Access Compliance Report

Public Rights-of-Way

Intersection ID: 2905	Main Street: RIDGE_RD	Cross Street: SHELLEY_AV	Location: SE
ADA ID: D3C134ADD3A9	Ramp Type: Perp	Initial Pass/Fail: Fail	Overall Compliance: No
		Severity Score: 8.75

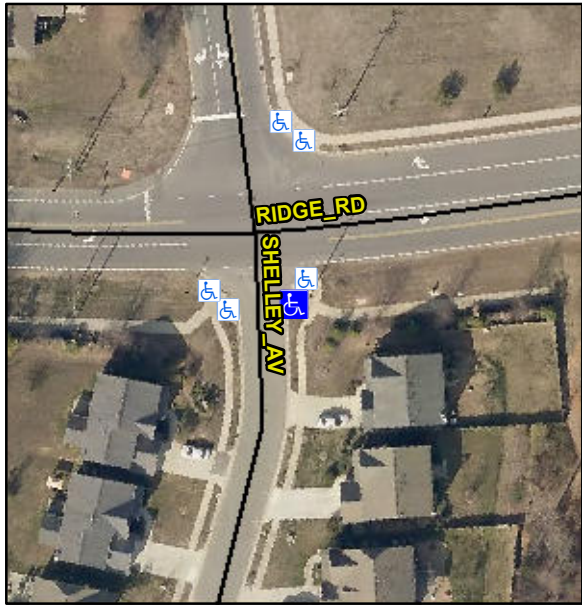
Codes/Mitigation Info/Possible Solution			Field Measurements/Component Compliance								
	Possible Solutions:		Compliance			Description			Data		
	Remove & Replace Entire Ramp.		N/A	Ramp Length (in)		130.0	Yes	Ramp Slope (%)		5.3	
			No	Ramp Width (in)		41.0	Yes	Ramp XSlope (%)		1.3	
			N/A	Flare Type LT		N/A	N/A	Flare Type RT		N/A	
			N/A	Flare Slope LT (%)		N/A	N/A	Flare Slope RT (%)		N/A	
			N/A	Flare Traversable LT?		N/A	N/A	Flare Traversable RT?		N/A	
			N/A	Landing Length (in)		N/A	N/A	DWS Provided?		N/A	
			N/A	Landing Width (in)		N/A	N/A	DWS Contrast?		N/A	
			N/A	Landing Slope (%)		N/A	N/A	DWS Length (in)		N/A	
			N/A	Landing X Slope (%)		N/A	N/A	DWS Full Width?		N/A	
Surveyor Notes:	N/A		N/A	Landing Curb? (Y/N)		N/A	N/A	DWS Offset (in)		N/A	
			N/A	Shared Landing?		N/A					
			N/A	Gutter Ponding?		N/A	N/A	Gutter Slope (%)		N/A	
			N/A	Gutter Lip Ht (in)		N/A	N/A	Gutter X Slope (%)		N/A	
			N/A	Painted X Walk1?		No	N/A	Painted X Walk2?		N/A

X Walk 1 Direction		To W		X Walk 2 Direction		N/A	
			N/A	X Walk 1 Width (in)		N/A	N/A	X Walk 2 Width (in)		N/A	
				X Walk 1 Slope (%)		2.8		X Walk 2 Slope (%)		N/A	
				X Walk 1 X Slope (%)		2.6		X Walk 2 X Slope (%)		N/A	
			N/A	Ramp inside XWalk1?		N/A	N/A	Ramp inside XWalk2?		N/A	
PROW/ADA:	R304.5.1			Road Slope (%)		N/A	N/A	Clear Space?		N/A	
				Road X Slope (%)		N/A	N/A	Clear Space to XWalk (in)		N/A	
			N/A	Any Obstructions?		N/A	N/A	Storm Grate/Utility Hazard?		N/A	
				Obstruction Type				Storm Grate/Utility Type			
							N/A			N/A	
							Yes	Surface Condition? (G/P)		Good	
	Total Cost:		\$ 1850.00
